Supporting Documentation: What other options to meet the need were considered, taking point 6 and the impact identified in the Statement of Significance into account?

Figure 2: Option 4, June 2020. See text for details.

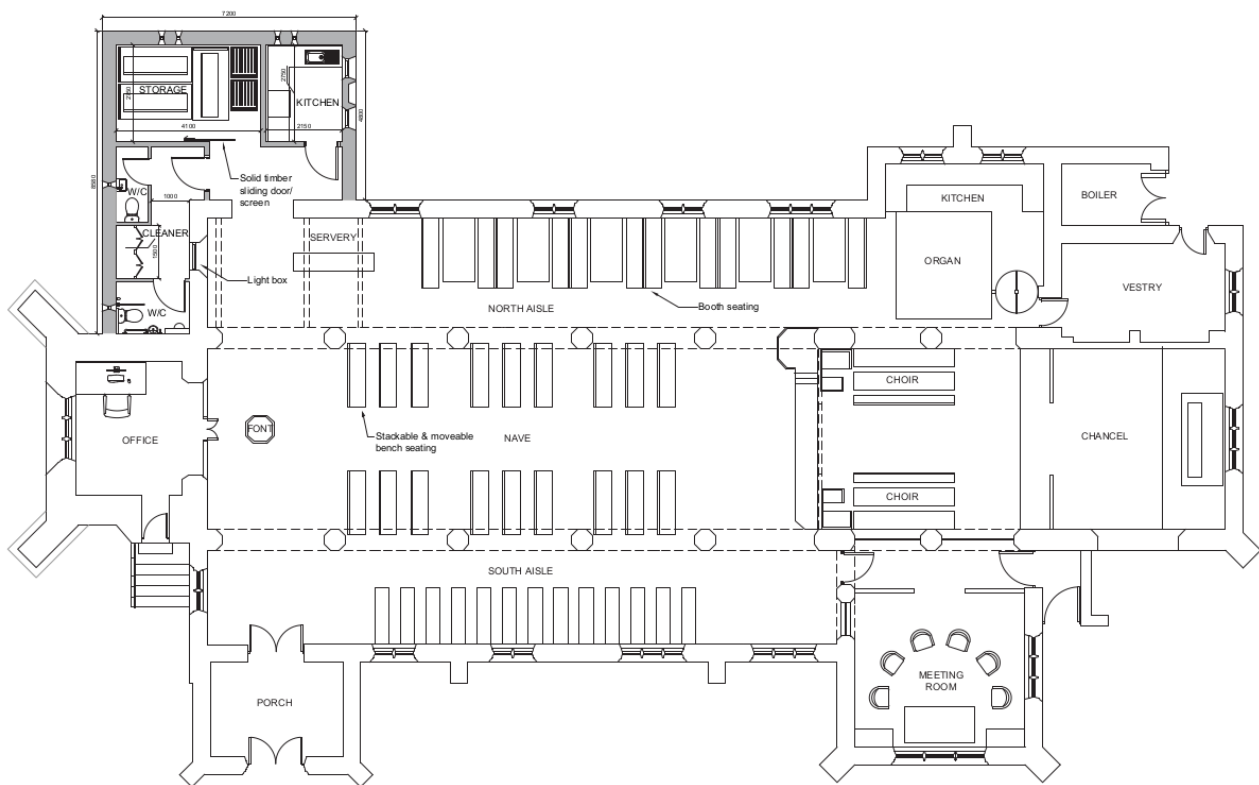
We undertook a preliminary consultation with the DAC on option 4.

The DAC commended the parish and their architect for demonstrating their consideration of a range of options, and noted they did not consider the pews to be of highest quality. Further, they questioned whether the arrangement of pews facing each other in the café area was the best solution in terms of flexibility of the space and suggested the parish may wish to reconsider the configuration of this area. They wondered if the kitchenette may be too small, and did not feel there was a need for improvement of the heating.

The DAC feedback made the church realise it has offered a compromised proposal which did not fully meet our needs, rather was aimed at being acceptable to stakeholders, as was perhaps evident in the aforesaid advantages and disadvantages noted for option 4. This encouraged the PCC to replace the pew benches and pew booths with chairs. In subsequent discussions, the partial retention of pews in the South aisle was challenged by the PCC and members of the church community. It was felt the South aisle would become dead space, and the aesthetic of the church would be unbalanced with mostly chairs and a small number of pews. These factors combined with ongoing and further analysis of the uses of the church, and reasons to be noted presently, led to the option of our submitted faculty, **option 5, c. February 2022.**
